**--- West Contra Costa Sanitary Landfill, Inc. ---**  
**MEMORANDUM**

**Subject: COMMENTS ON DRAFT EIR**

The following are our comments derived reviewing the Draft EIR for the WCL Bulk Materials Processing Center and Related Actions.

**FIGURE 2**  
**WEST COUNTY LANDFILL, INC.**  
**WEST CONTRA COSTA SANITARY LANDFILL**  
**RICHMOND, CALIFORNIA**  
**LOCATIONS OF TEST BORINGS AND**  
**SLOPE STABILITY CROSS SECTIONS**

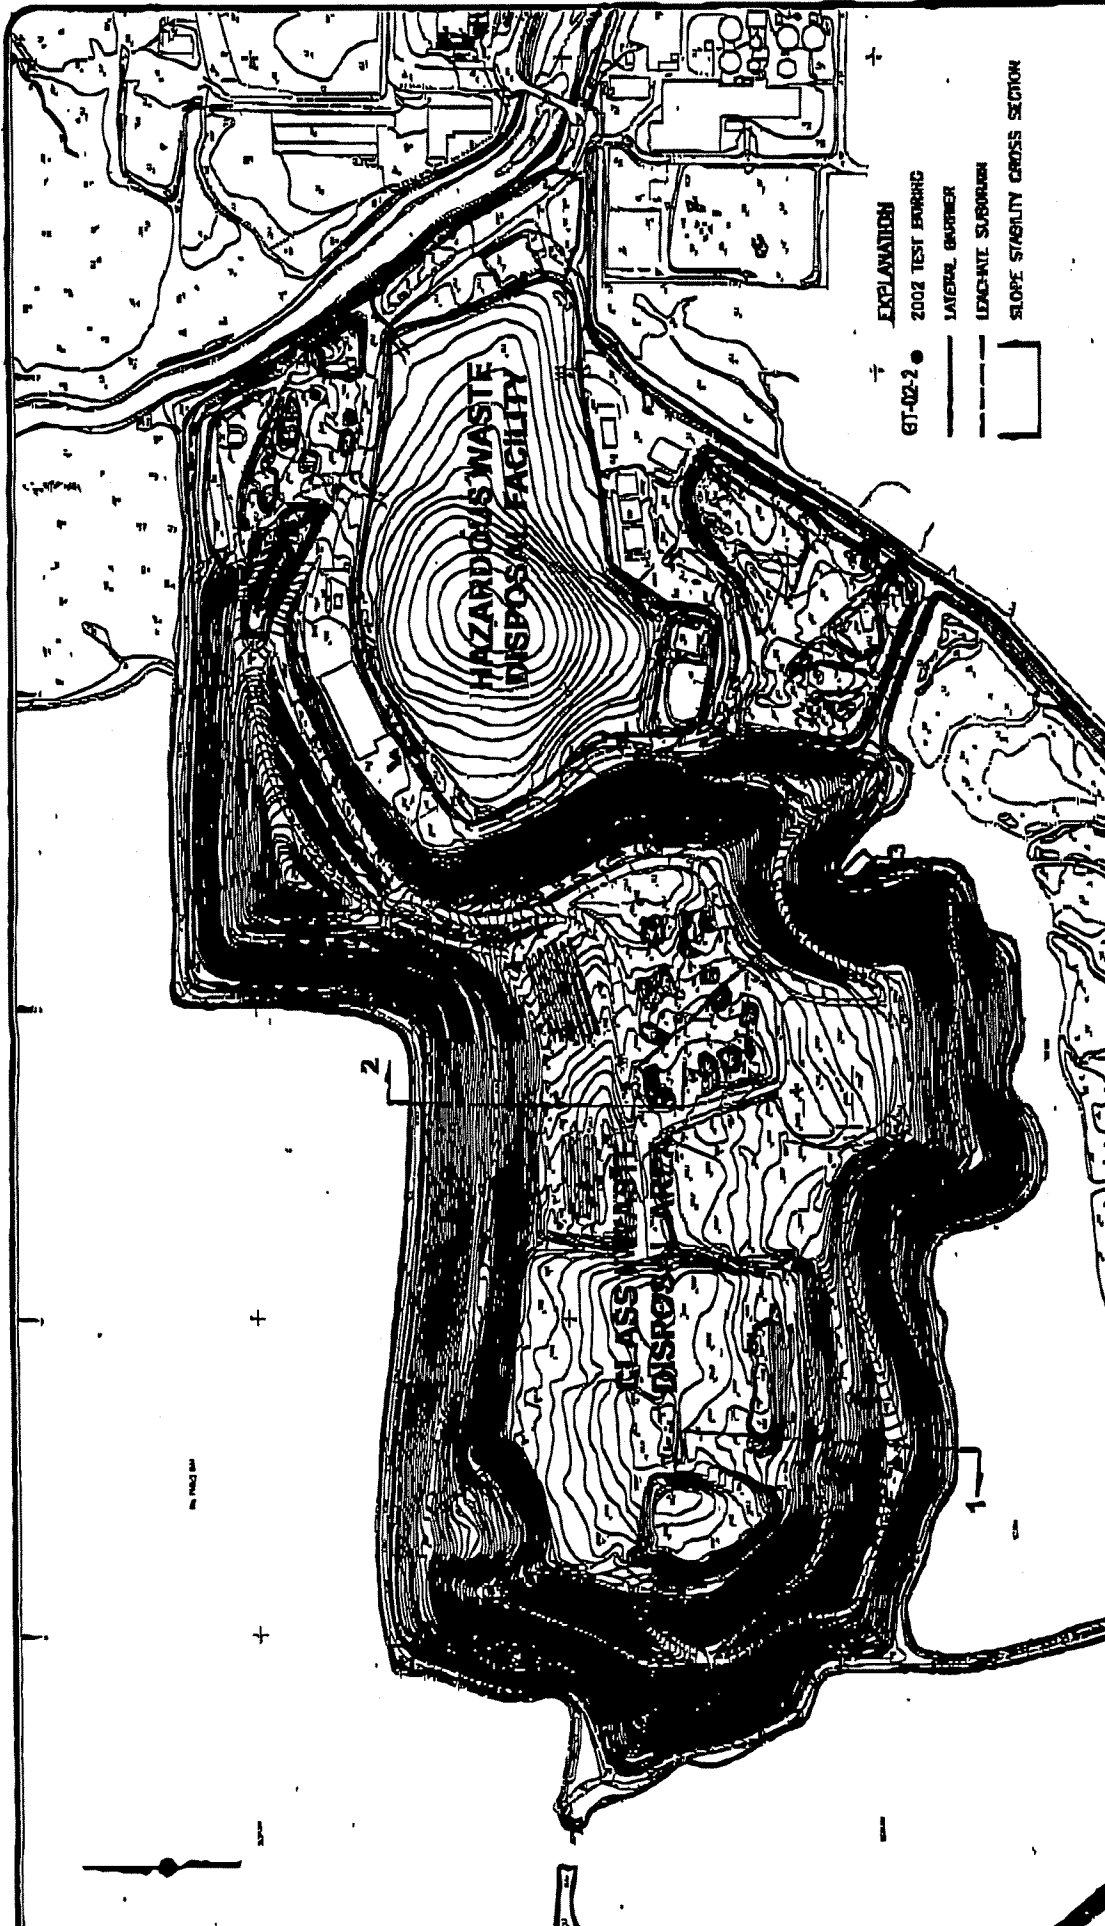
- Pg 5-17 – The further study of liquefaction was postponed until 2004 while awaiting the RWQCB review of the documents submitted by WCCSL, Inc. during 2003. 17-17
